CITY OF NAPOLEON - BUILDING DEPARTMENT

RESIDENTIAL PLAN CORRECTION SHEET

ADDENDUM TO Permit No. 01962
Owner MARGARITA R. TOETA
Contractor FRANK P. BOLLIG
Location 840 CANTON GARAGE

to [Bullock GARAGES]
[4730 W. BARNZDRETT #17]
[TOLEDO, OHIO 43615]
subject 840 MONROE ST. RIVERA GARAGE

QUALITY CONSTRUCTION

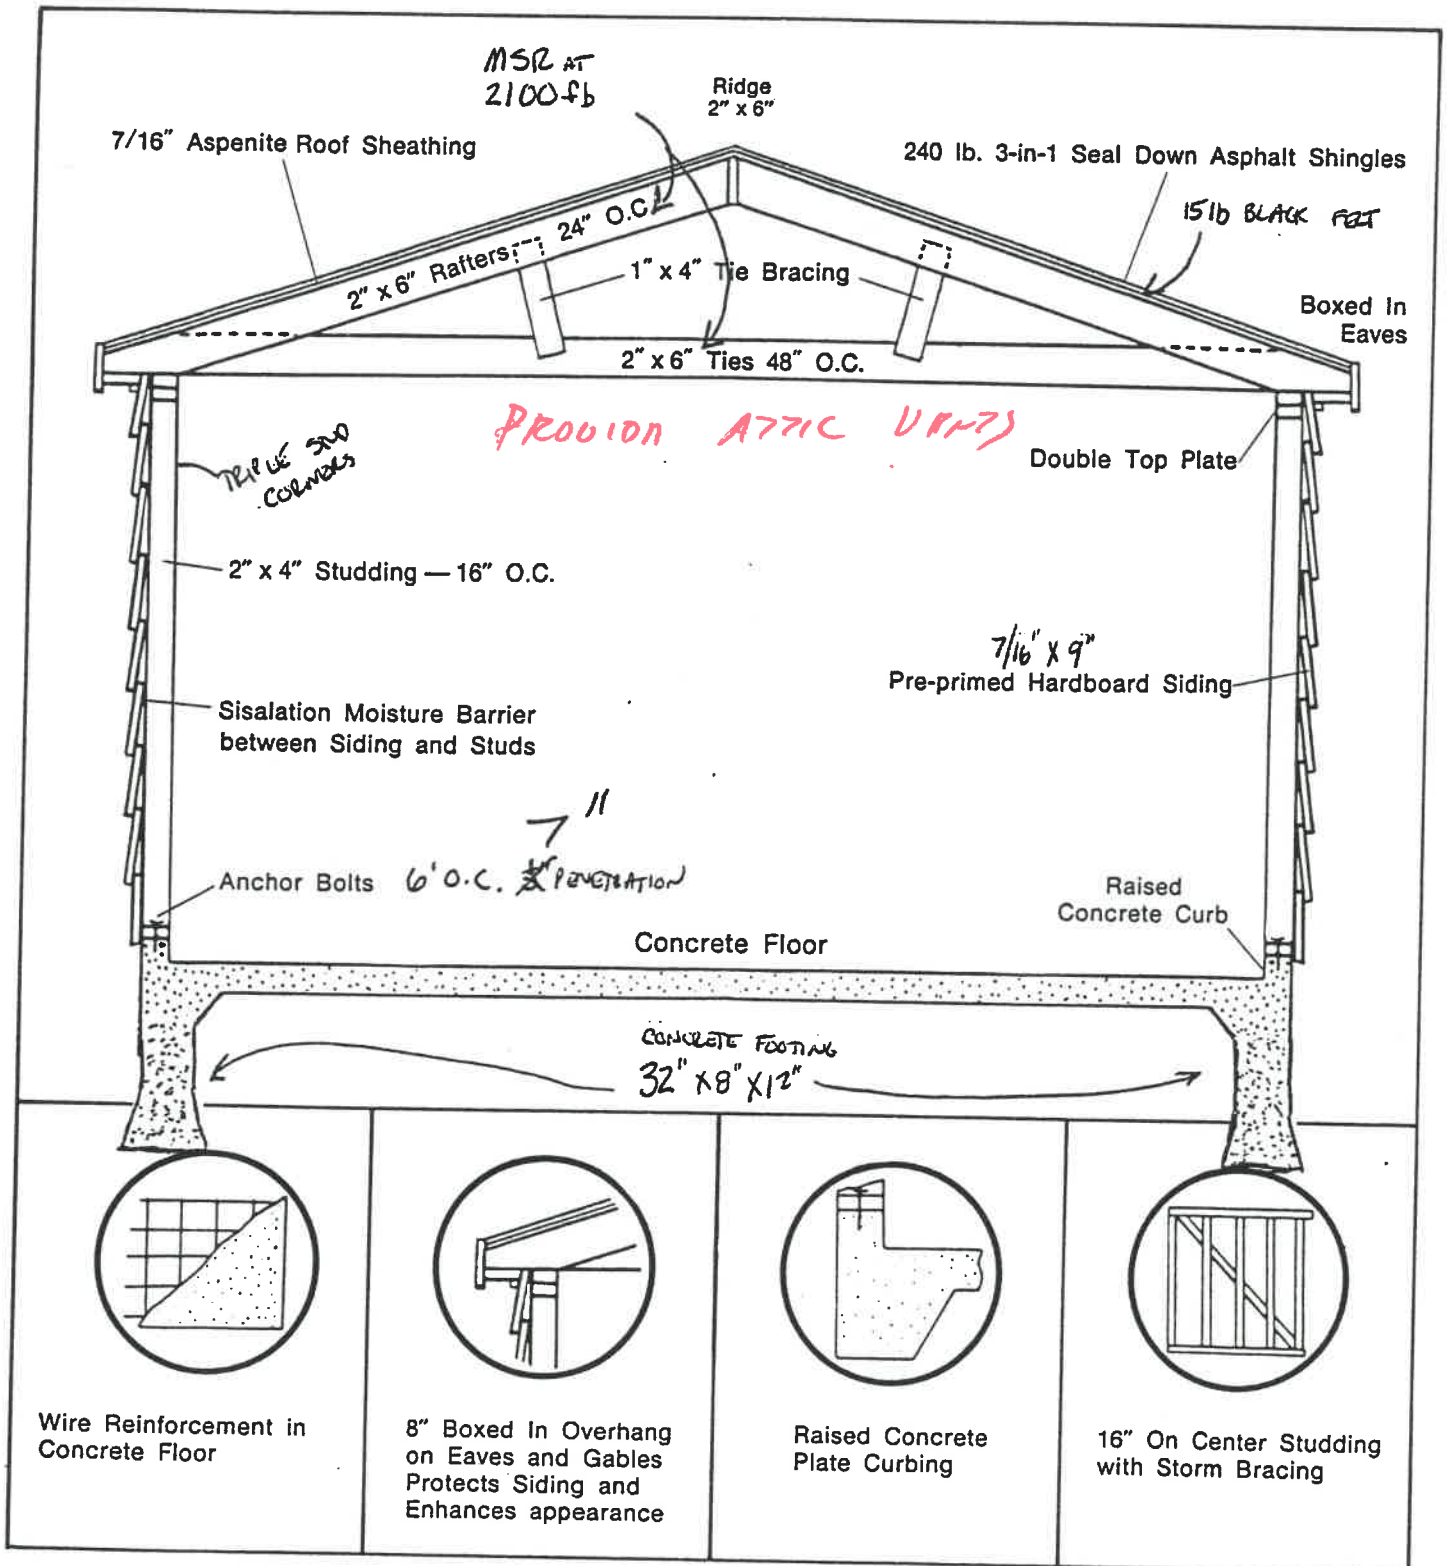
GENERAL		
<input checked="" type="checkbox"/>	Provide approved smoke detector(s) as req'd.	
	Provide 1/2" gypsum wallboard between dwelling and garage, on garage side.	
	Provide min. 1 3/8" solid wood door from garage to dwelling. (or equal)	
	Submit fully dimensioned plot plan.	
	Provide min. of 1-3'0" x 6'8" exit door.	
	Provide min. 22" x 30" attic access opening.	
	Provide min. 18" x 24" crawl space access opening.	
	Provide approved sheathing or flashing behind masonry veneer.	
	Provide min. 15# underlayment on roof.	
	Provide adequate fireplace hearth.	
	Install factory built fireplaces/stoves according to manufacturers instructions.	
	Terminate chimney 2' above roof or 2' above highest point of building within 10' of chimney.	
LIGHT AND VENTILATION		
	Provide mechanical exhaust or window in bathroom	
<input checked="" type="checkbox"/>	Provide min. <u>250</u> Sq. In. net free area attic ventilation.

Provide min. _____ Sq. In. net free area crawl space ventilation.	
FOUNDATION		
	Min. depth of foundation below finished grade is 32".	
	Min. size of footer _____" x _____"	
	Provide anchor bolts 1/2" @ 6' o.c. 1' from each corner. Embedded 7" in concrete and 15" in masonry.	
	Show size of basement columns.	
FRAMING		
	Show size of wood girder in _____.	
	Provide design data for structural member in _____.	
	Floor joists undersized in _____.	
	Provide double joists under parallel bearing partitions.	
<input checked="" type="checkbox"/>	Provide 1" x 4" let in corner bracing, approved sheathing, or equal.	
	Show size of headers for openings over 4' wide _____.	
	Show size of members supporting porch roof.	
	Provide double top plate for all bearing partitions and exterior walls.	
	Provide design data for prefab wood truss.	
	Ceiling joists undersized in _____.	
	Roof rafters undersized in _____.	
PLUMBING AND MECHANICAL

CLARIFICATION (A) EXCAVATED DIRT IS TO BE PLACED
ONLY OUTSIDE THE BOUNDARIES OF
THE BUILDING. NOT UNDER THE SAND
COMPLETED (B) THE VEGETATION AND TOP SOIL MUST BE
REMOVED. BEFORE YOU CALL
FOR INSPECTION (C) THE FOOTINGS MUST BE A MIN. WIDTH OF 12"
MIN. DEPTH 12"
(D) A MIN 9" THICK STONE BASE MUST BE INSTALLED
TO BOT OF FOOTING
(E) THE FOOTING TRENCH MUST BE GROUND CLEAN.
date 5-9-90 signed ELDON HUBER date signed
